Bethesda Downtown Design Advisory Panel

Meeting Minutes

PROJECT: 7000 Wisconsin Ave
Site Plan No. 820200090

DATE: January 22, 2020

Massing Comparison

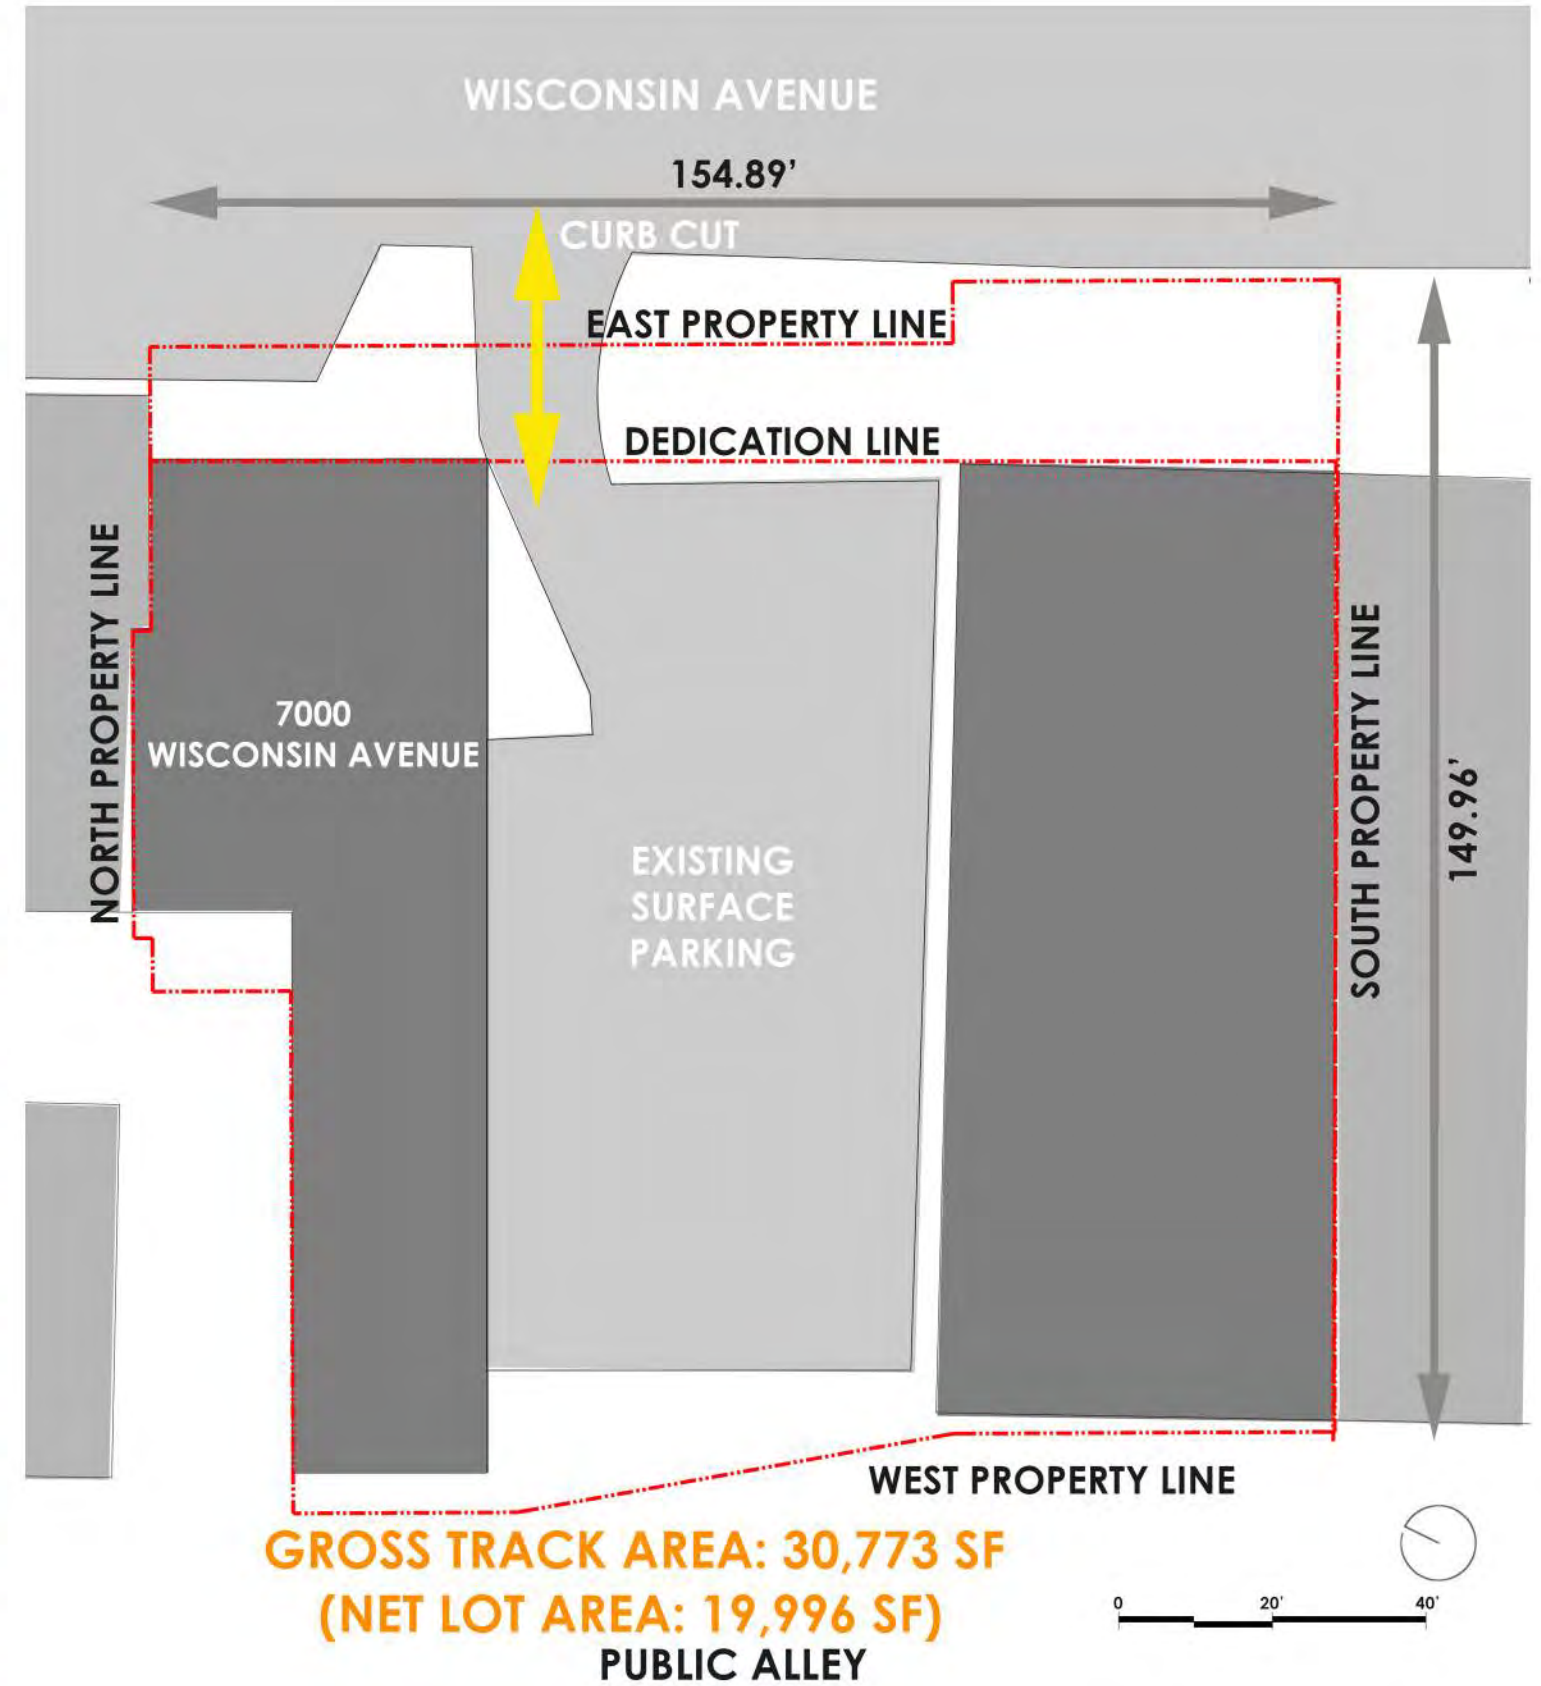
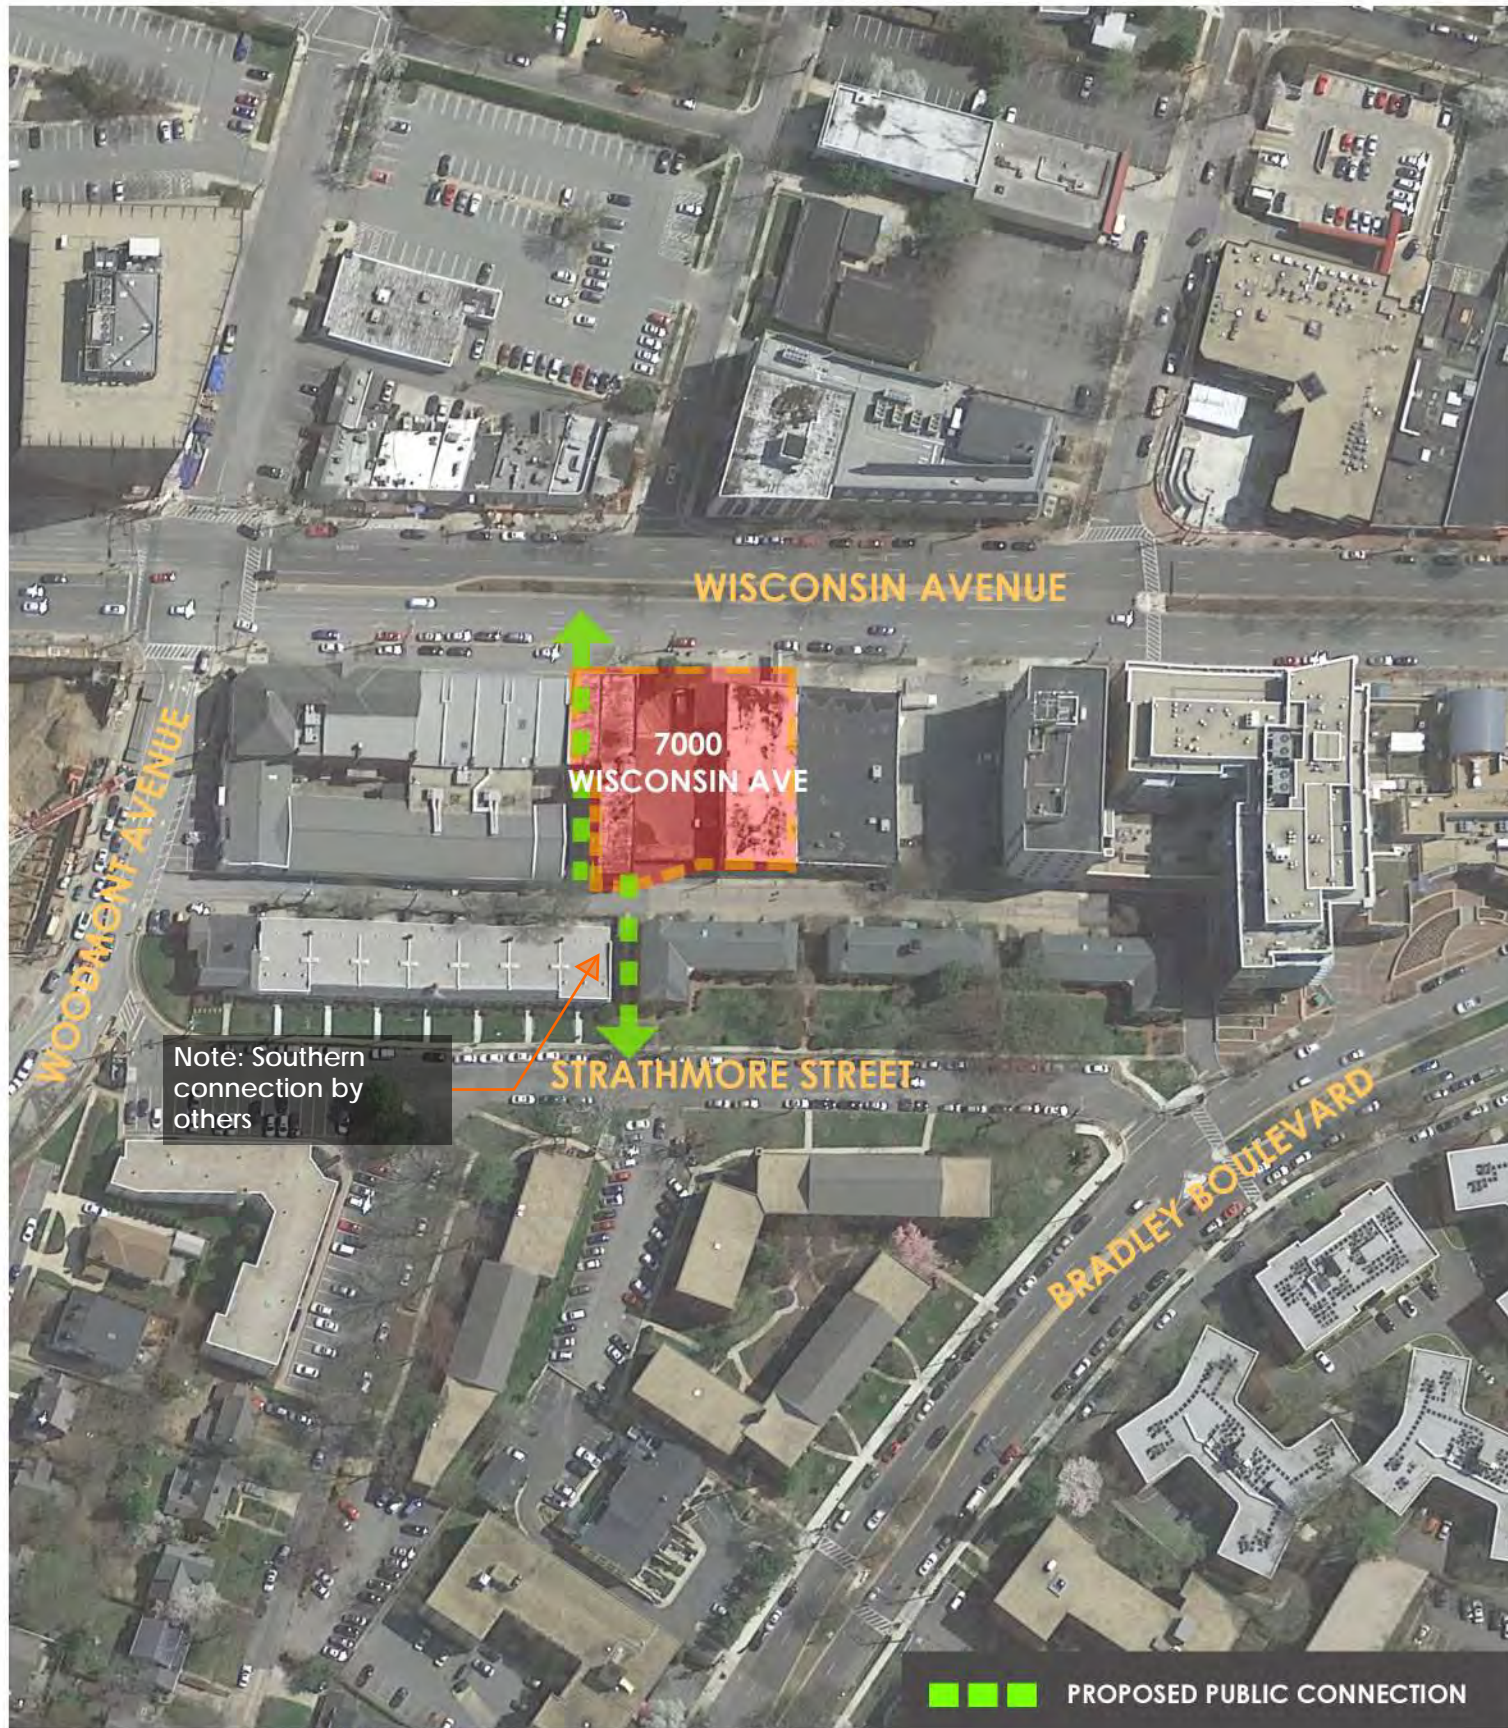
1. 45' base and 6' set-back
- 2a. tower separation above the base on Wisconsin Ave. to reduce monolithic building facade
- 2b. set-back on the North side(minimum 15' deep)
3. alternate treatments of the base to accentuate the tower separation efforts
